## ON-SITE SEWAGE DISPOSAL SYSTEM HOWARD COUNTY HEALTH DEPARTMENT BUREAU OF ENVIRONMENTAL HEALTH

SUBDIVISION: Gaithers Sideling LOT NUMBER: 8

LDE Inc. Engineers, Surveyors, Planners 9250 Ramsey Road, Suite 106 Columbia, Maryland - 21045 (410) 715-1070 - (301) 596-3424 - FAX (410) 715-9340		
DESIGNED SDH	Custom Grading Plan for Building Permit  GAITHERS SIDELING - SECTION 4 LOT 8	SCALE 1" = 40'
DRAWN MDL		DRAWING 1 of 2
CHECKED BDB		JOB NO. 05-200,29.1
DATE 9/20/05 REV 10/05	DEVELOPER Barry Hogan 2055 Bandy Avenue Sykesville, MD 21784	FILE NO.

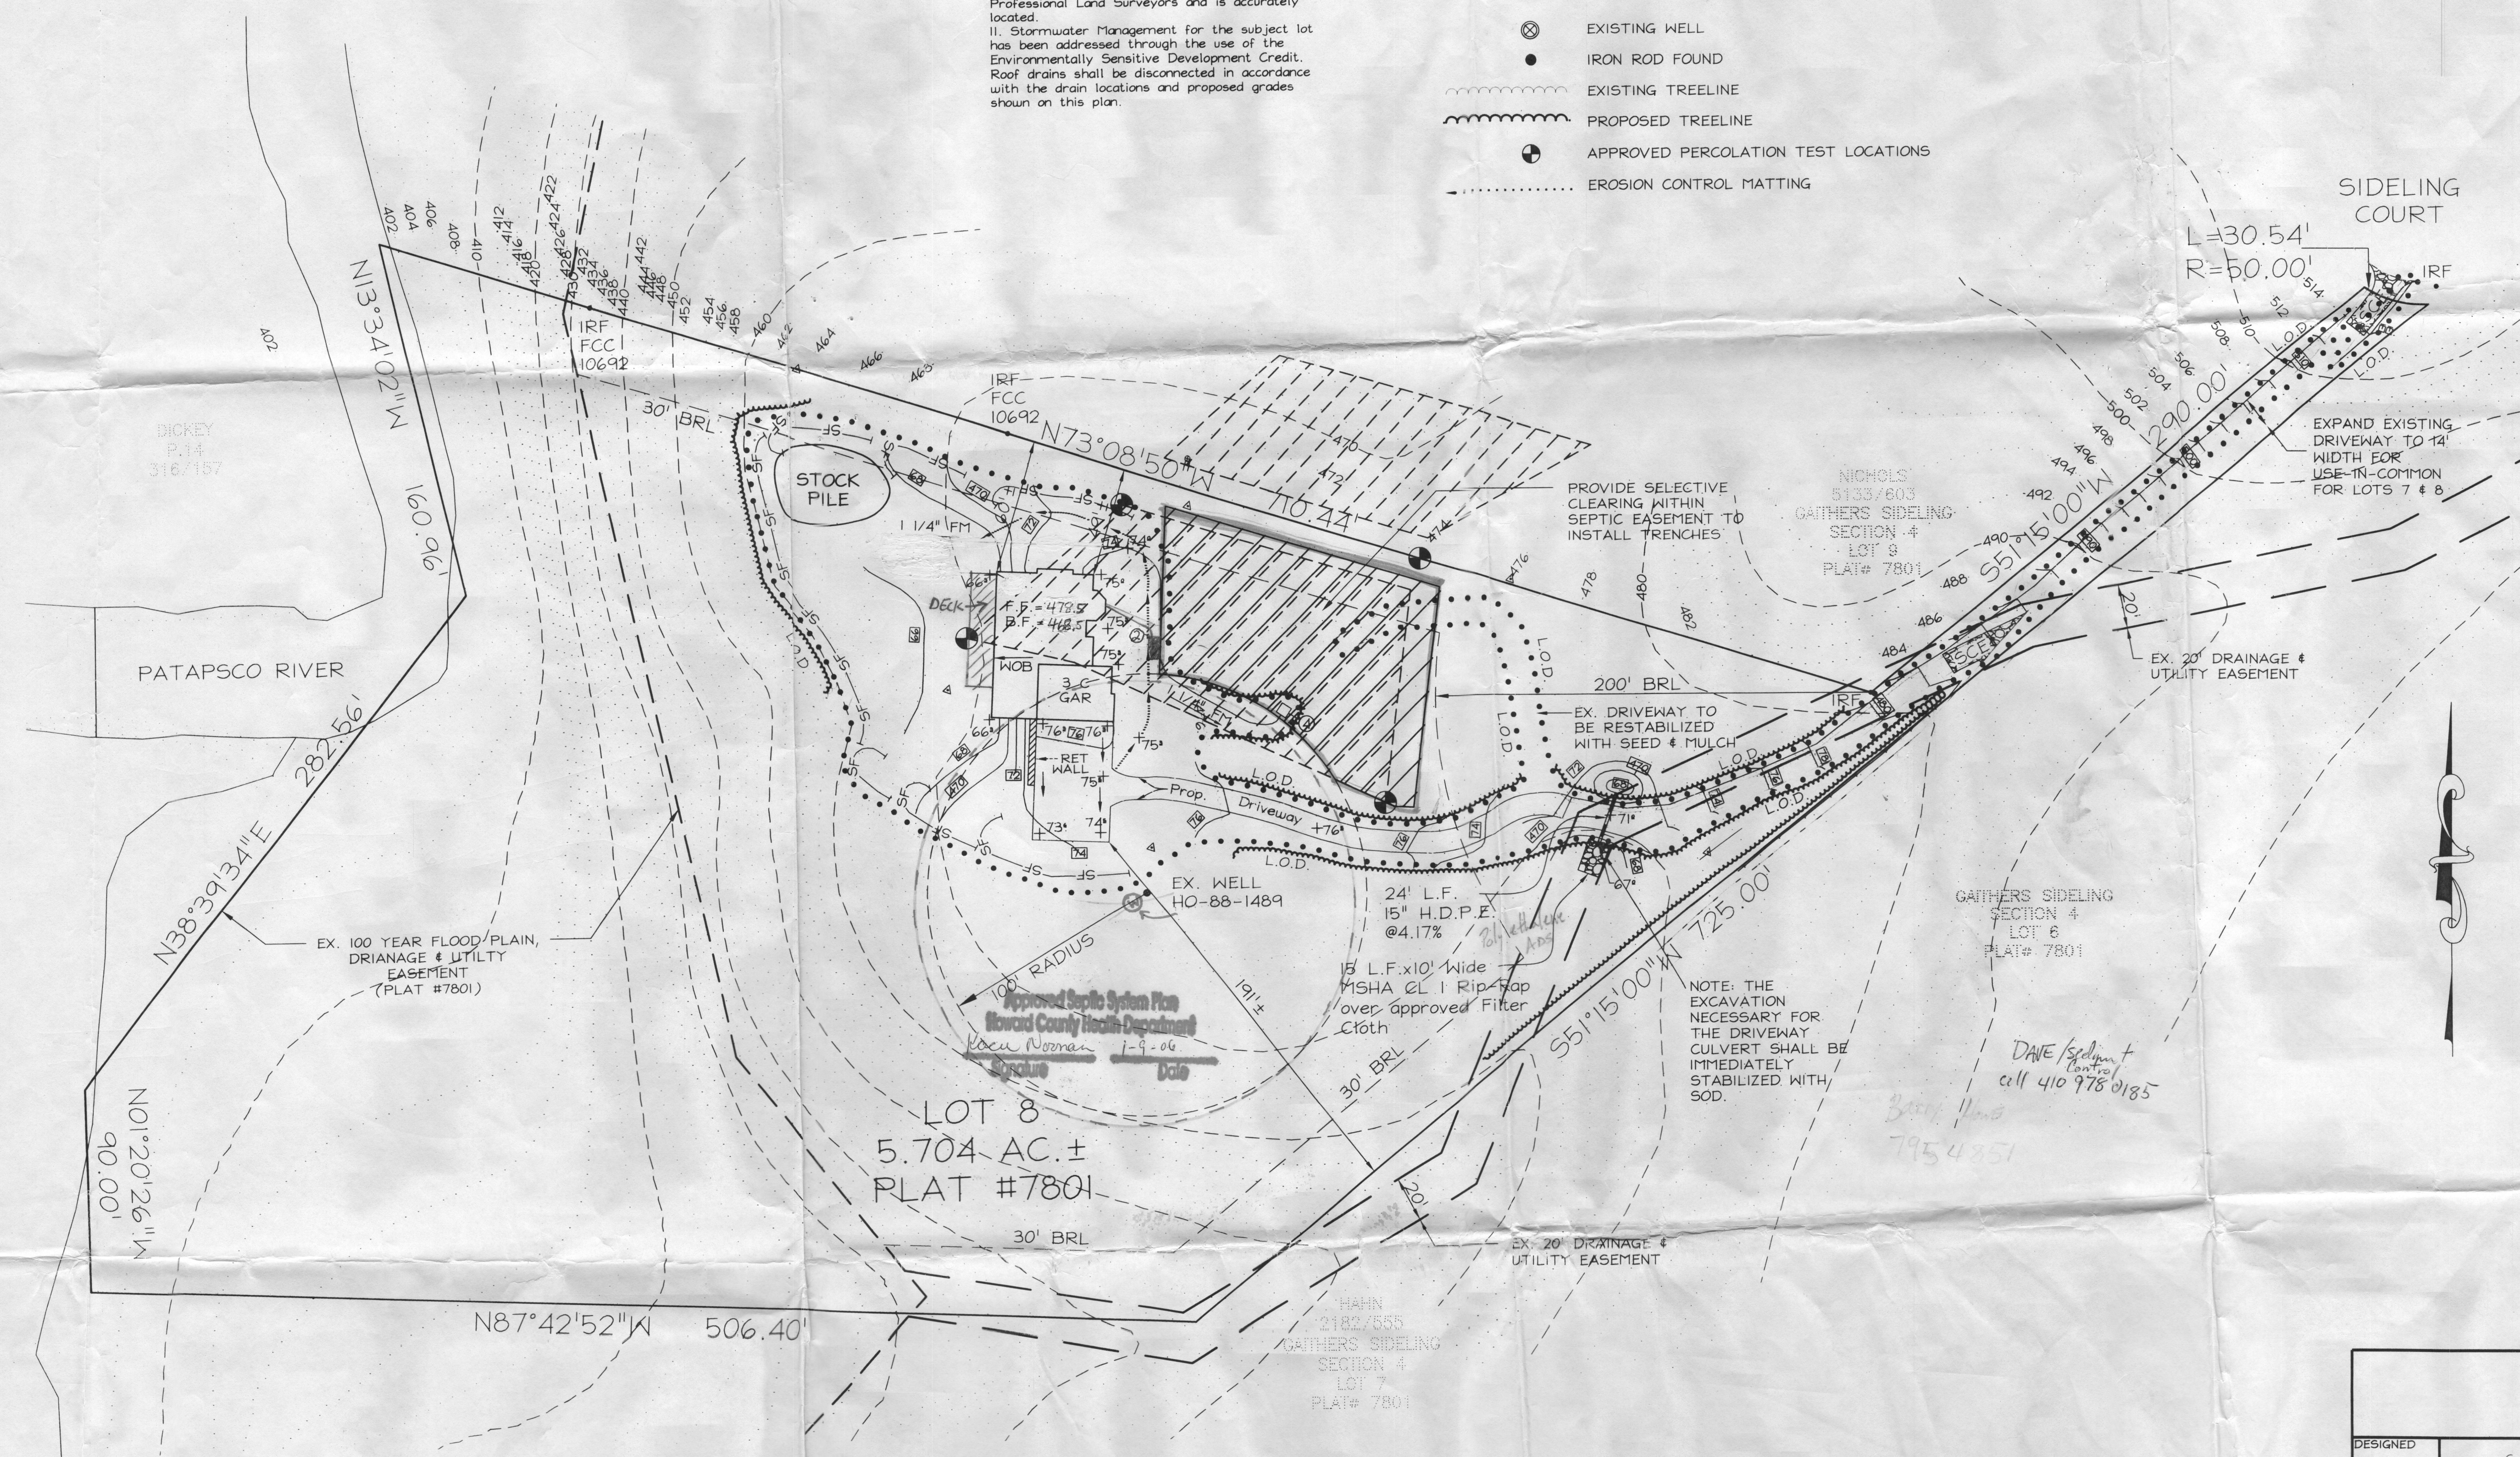
PRE-CONSTRUCTION 5/9/06 Run 2x80' trenches straight ahead out of front of tank/House skirting the well radius. (GAC)

INSTALLATION Sleeve ~~connection~~ Connection 10' on either side of ~~well~~ line (GAC) 5/10/06 OK to cover system. (GAC)

- ~~See~~ See approved Septic System plan for true well site.
